**MAJOR PROJECT ASSESSMENT:  
Redevelopment of  
Sydney Showground Main Arena  
Sydney Olympic Park  
(MP 10\_0145)**

Director-General's  
Environmental Assessment Report  
Section 75I of the  
*Environmental Planning and Assessment Act 1979*  
March 2011

**Figure 7: Proposed Green Wall (Stage 1 Variation)**

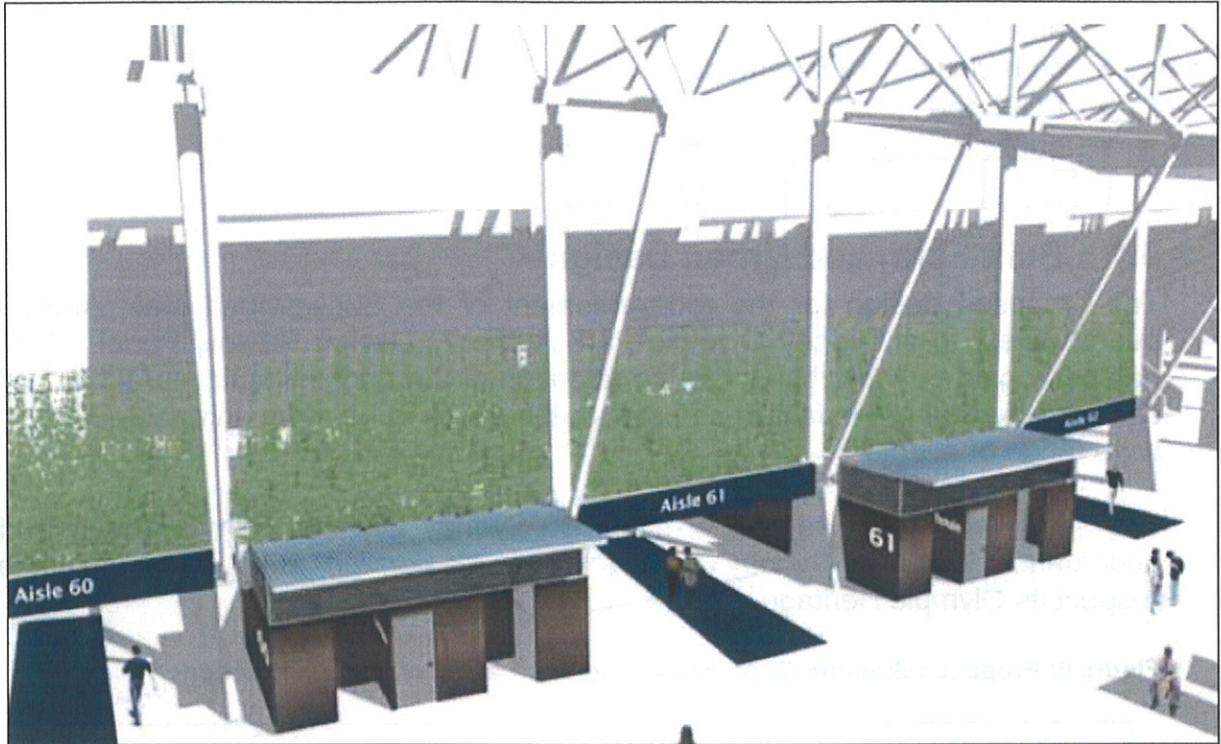
An area of concern is the green wall that has been proposed to mask the concrete facades. The Department notes that, as outlined in the proponent's Architectural Design Statement *'in Stage 1 the green wall will not be built to front the south-east and north stands due to the slightly different location of these stands relative to the permanent versions and also due to the prohibitive impact they will have on constructing permanent stands in the future. In this instance the stands to these areas will be screened with an appropriate design response'*.

This presents the possibility of the unsightly concrete facades of the stands being left exposed until any future funding is negotiated. If the temporary seating option, namely Stage 1, is implemented, the Department will require a schedule of finishes to be presented to the satisfaction of both the Department and SOPA. A condition will be imposed to ensure that this is carried out prior to the issue of a Construction Certificate.

The Department is generally satisfied that the proposal is of a reasonable quality and appropriate design for the location and will have minimal visual impact on surrounding development. The Department supports the inclusion of the green wall and, in the case that Stage 1 is pursued, believes that it would be appropriate for an alternative screen or high-quality finishing to be used.

**Figure 9: Proposed Toilet Block Façade Design**

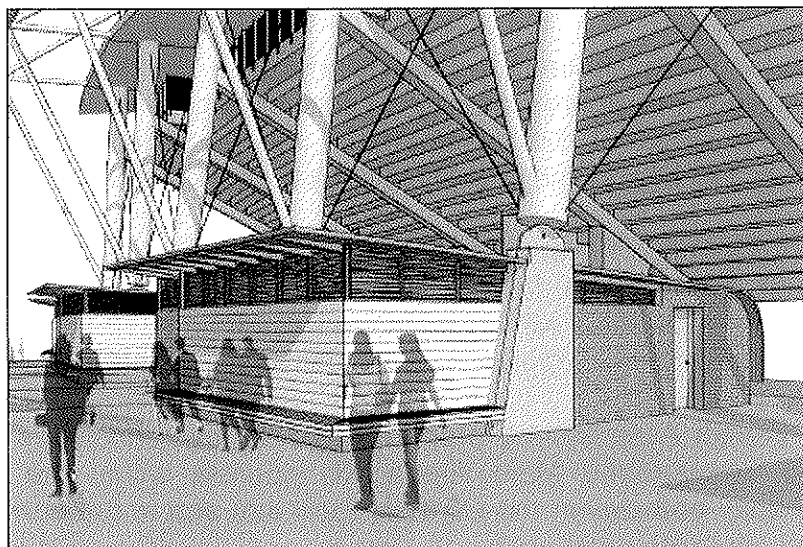
Issues were raised by SOPA in their submission to the Department regarding the lack of information provided regarding detailed elevations, cross sections and material samples. Additional concerns were raised by SOPA regarding the proposed design of the toilet blocks that were described as representing 'a distinctively municipal character' and failing to achieve the design objective of an 'agricultural soul' (Figure 9). The bunching of the toilet blocks at the south-eastern edge was also identified as a potential problem relating to crowding.

The proponent provided additional illustrative plans in their RtS and proposed that an on-going dialogue with SOPA will take place after the assessment process to resolve any design issues that arise. The proponent included this in their Statement of Commitments. SOPA supported this approach and the Department has imposed a condition requiring detailed designs of the roof structure, ground plane, perimeter fencing, public domain, landscape plans and toilet blocks, and sample boards including specifications and actual samples, be submitted to SOPA and approved by the Director General prior to the issue of a Construction Certificate.

**Figure 11: Fencing Detail and layout (shown in blue)**

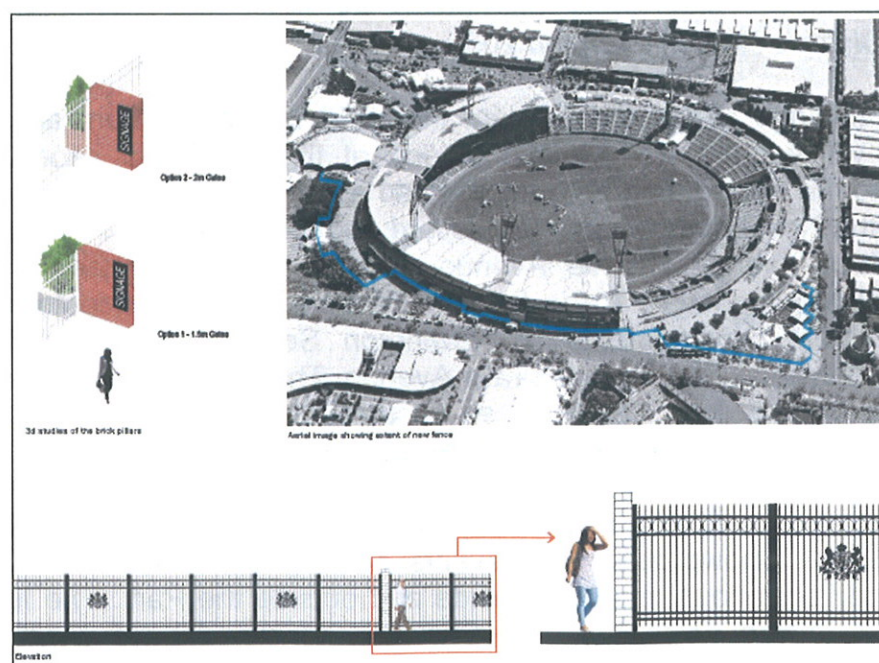
The fence will be constructed of brick pillars and open cast iron fencing with RAS emblems embedded within sections of the fence. The design will attempt to recreate the fencing at the original Moore Park site. Crowd loading and entrance/exit locations will be refined during the design development phase.

The Department is satisfied that the proposed fencing is suitable for the site and the retractable nature will allow movement across the site when required.
